**Flood Control Project Maintenance  
Levee Inspections****LMA District Cover Sheet  
Spring 2014 Levee Inspection Results****Reclamation District No. 1602 Del Puerto**

**Reclamation District No. 1602 Del Puerto**

Waterway			Bank	Unit Miles
Unit No. 01 San Joaquin River			Left	6.29
	Spring (March - May)	Summer (June - August)	(September - November) Fall	Winter (December - February)
Unit Maintenance Rating (Fall Only)				
Date of Inspection	04/24/2014 - 04/24/2014			
DWR Inspector	Pavel Kazi			
Accompanied By	Tony Martinez RD1602

**Levee Inspection Report By Mile - Spring 2014**

Photo 1 of 1 : pkazi\_s\_20140415\_641.jpg

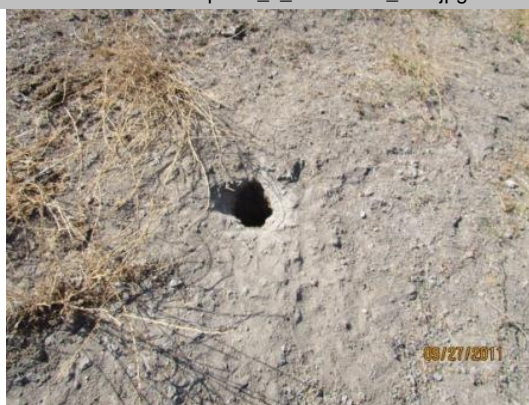
LM Start	1.13	Rating **	M	Issue No.	7
LM End	1.13	Issue Type +	Ma	Location *	LS
Category	Earthen Levee			GPS Latitude/Longitude	
				Start	End
Item	Animal Control			37.478331 °	37.478331 °
				-121.066705 °	-121.066705 °
DWR ID	DWR_RD1602_01_s_2012_7				
Action/Comments					
Exterminate rodents and backfill and compact or grout burrows.

Animal burrow was found on the landside of the levee. The picture was taken from the toe of the levee looking upstream.
